Appendix I of RNTPC
Paper No. A/YL-PS/622D

Re: ***Section 16 Planning Application for Proposed Temporary Transitional Housing for a Period of 3 Years in Lots 387 S.B ss.1 RP, 387 S.B ss.4 and 387 S.B RP in D.D. 122, and Adjoining Government Land, Ping Shan, New Territories***

RE: Light Village - Planning Application No. A/YL-PS/622 (South Site) and A/YL-PS/623 (North & Middle Sites)

Improved Scheme submitted to
TPB on 5 March 2021

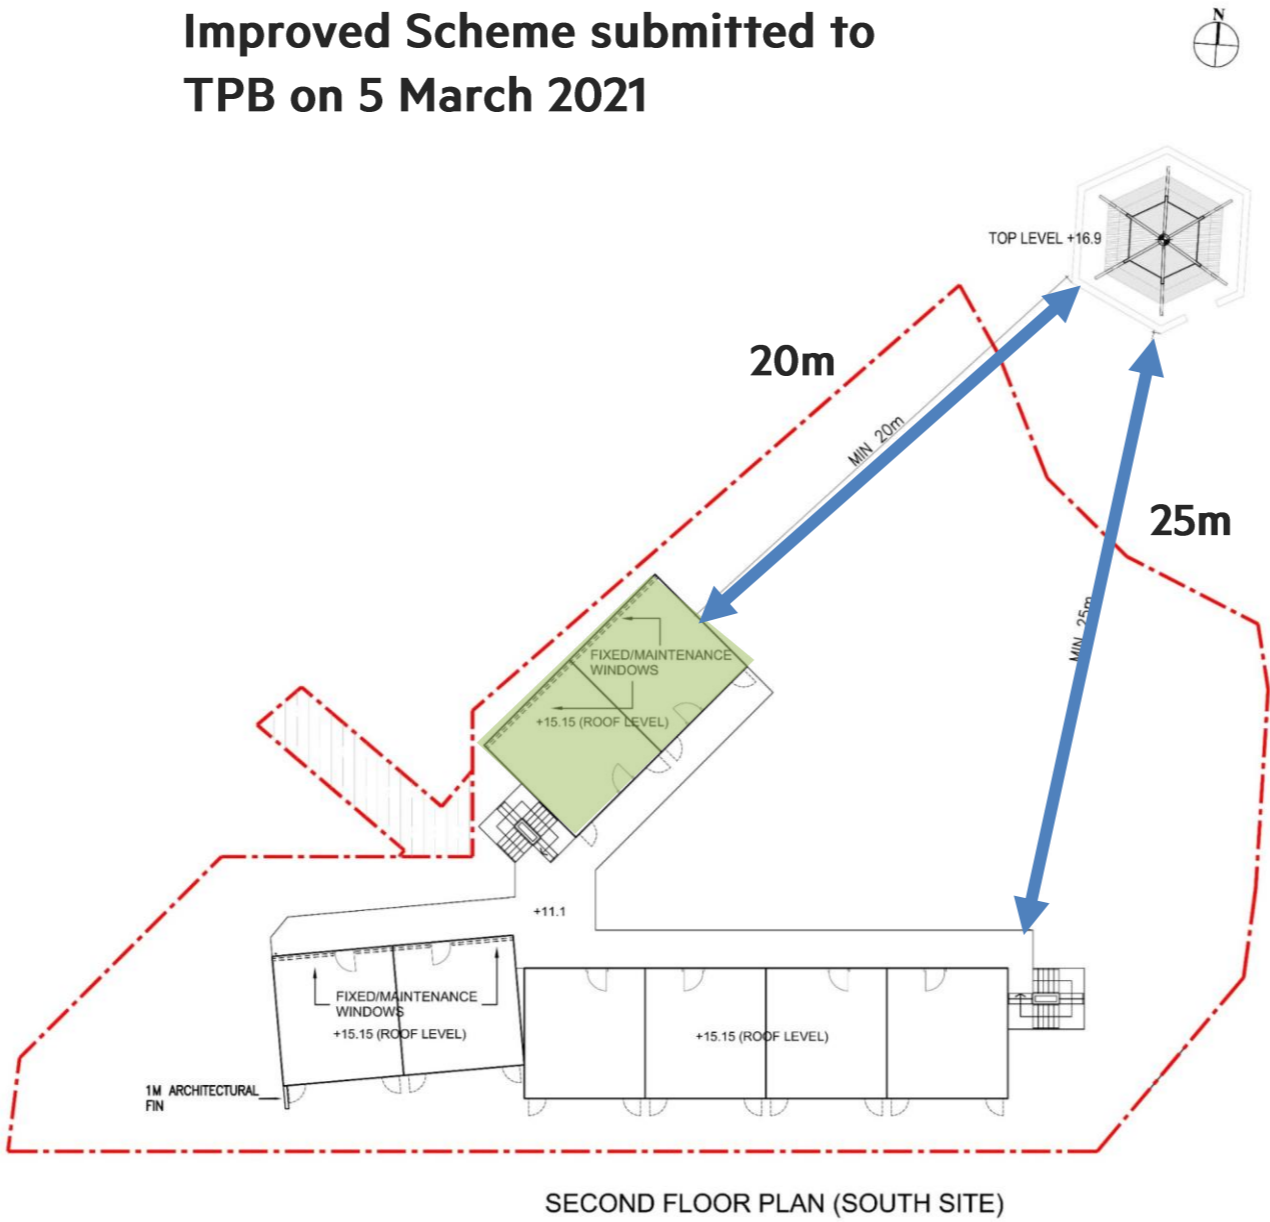
Comments	Response
<p>6. Chief Town Planner/Urban Design and Landscape (Urban Design Unit), Planning Department (Contact Person: Ms. Elizabeth NG, Tel: 2231 5067)</p>	
<p>A/YL-PS/622 (South Site)</p> <p>(i) VP2 in Figure 3 – The proposed development is quite visible to this VP and the existing openness would be significantly altered by proposed building mass. Please re-examine the result of “slightly adverse”.</p> <p>\</p> <p>(ii) VP3 in Figure 4 – Obviously the proposed development would lead to slight changes of the existing sky view. The result of “negligible” should be reassessed to reflect such changes.</p> <p>(iii) Mitigation measures in Para. 6.2 – The effectiveness of proposed mitigation measures such as aesthetic colour scheme in Figure 9, etc. should be illustrated in all photomontages if they are proposed to improve visual quality.</p> <p>(iv) Tsui Sing Lau Pagoda – The applicant should consider to add a viewpoint to assess any visual implications on the pedestrian/visitors near Tsui Sing Lau Pagoda.</p>	<p>i. It is agreed that there is room for improvement. To mitigate the visual impact, building block set back and stepped height design facing the pagoda are proposed. To further minimize the visual impact and improve visual openness, the east wing of the building block is now reduced from 3-storey to 1-storey. The improved scheme allows a more open sky view, a larger water feature and a spacious front yard as compared to the original proposed scheme. With the building setback and water feature at the entrance, as well as the wood and stone colour scheme which echoes the ambience of the pagoda, the visual impact from VP2 would be mitigated to a more acceptable level.</p> <p>ii. As shown in the photomontage of VP3, the proposed development (15.15mPD) is of comparable height to the Thai Restaurant (12.3mPD), the nearby village houses (12.5mPD) and the Pagoda (16.9mPD). It would only bring to slight change to the existing sky view whilst a large portion of the proposed development being screened by the existing vegetation. With the improved scheme, the east wing of the building block has been reduced from 3-storey to 1-storey which the building mass has been further reduced and the village houses at the back could be seen. Hence, very little visual changes would be resulted and there would be no significant visual effects to the VSRs. Considering the transient nature of VP3, the visual impact is considered negligible.</p> <p>iii. Relevant photomontages for VP2, VP3 and VP7 of the South Site are revised and enclosed in Attachment 2.</p> <p>iv. A viewpoint taken from Tsui Sing temporary car park (VP8) is added. VP8, located about 70m from the South Site, is a short distance view overlooking the pagoda and the Thai Restaurant. The lower part of the Thai Restaurant is being blocked by the fence wall of Elle Garden. Further back is the Ping Wu Garden with Tin Shui Wai MTR Station, Tin Yiu Estate and open sky view as the backdrop. There are existing temporary structures that have blocked the lower part of the pagoda. The VSRs are mainly the car park users tended to have short stay, viewer population and visual sensitivity of</p>

- MIN. 15m SEPARATION FROM PAGODA ON G/F
- LOCATION OF CREATIVE LEARNING & CULTURAL ACTIVITY ROOM AND HOUSING UNITS ARE SWAPPED
- DIMENSION OF HOUSING UNITS ARE ADJUSTED TO MAINTAIN SEPARATION FROM TSUI SING LAU PAGODA
- AREA OF TYPICAL UNIT REMAINS UNCHANGED

- MIN. 15-30m SEPARATION FROM PAGODA ON 1/F
- FLAT ROOF AT WEST WING REDUCES VISUAL OBSTRUCTION OF VIEWING TSUI SING LAU PAGODA FROM TSUI SING ROAD

- MIN. 17.5-30m SEPARATION FROM PAGODA ON 2/F

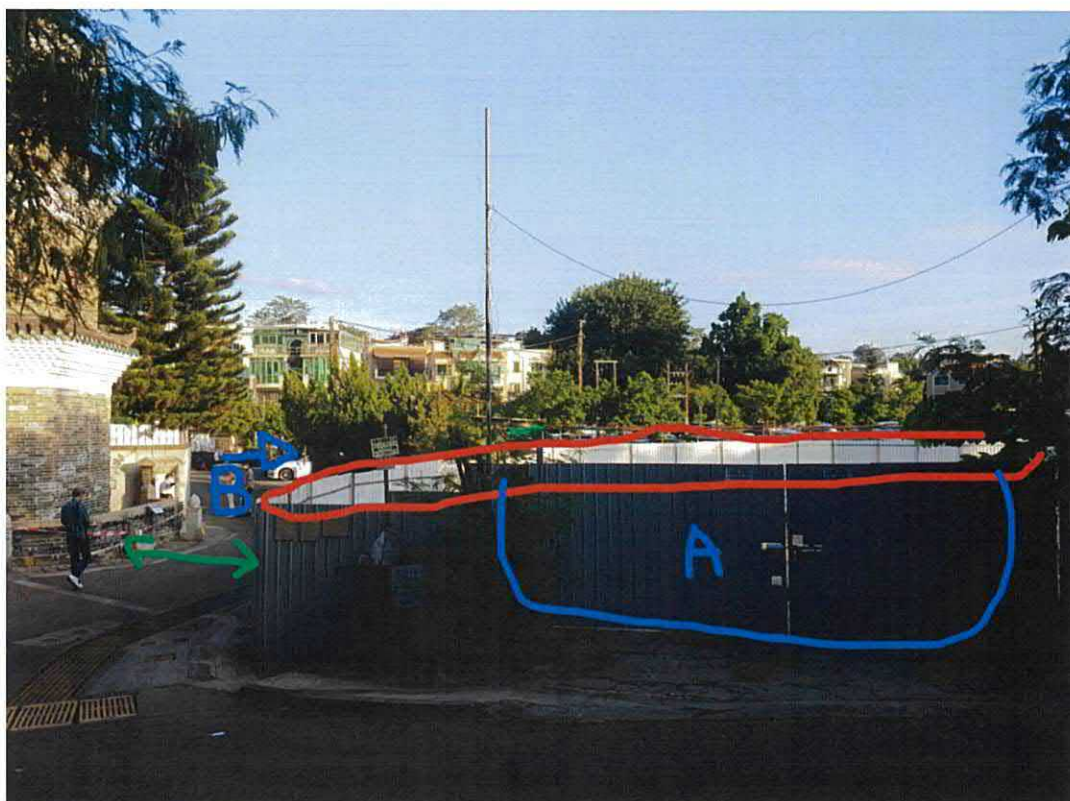
再者，在發展規範中的 Figure 3.8 的擬發展示意圖是有誤導公眾之嫌，除建築物比例有嚴重偏差外，示意圖中的背景及週邊環境亦全屬幻想之作，因是次申請的周遭環境實際上是十分擠迫的。本人建議各委員盡可能到實地視察，不要妄信申請人附上的示意圖。附件一是在 2020 年 12 月 1 日現場拍攝並沒有任何修飾的照片，以供參考。

- 照片中可見是次申請的用地早已在 A/YL-PS/594 的申請中剝離出去，並圍封起來，就是紅線的地方；
- 圍封後，A/YL-PS/594 的申請人把停車場的出入口由藍線的 A 點改到 B 點，引致聚星樓旁邊的雙向單程路車輛大增；
- 相片中綠色線可以見到地盤跟聚星樓的距離非常之近，只有 4 至 5 米，而這地方亦是遊人聚集和拍照的主要地方；
- 相片中亦清楚見到地盤周圍已有很多村屋，並不如發展規範中的 Figure 3.8 這樣空曠。
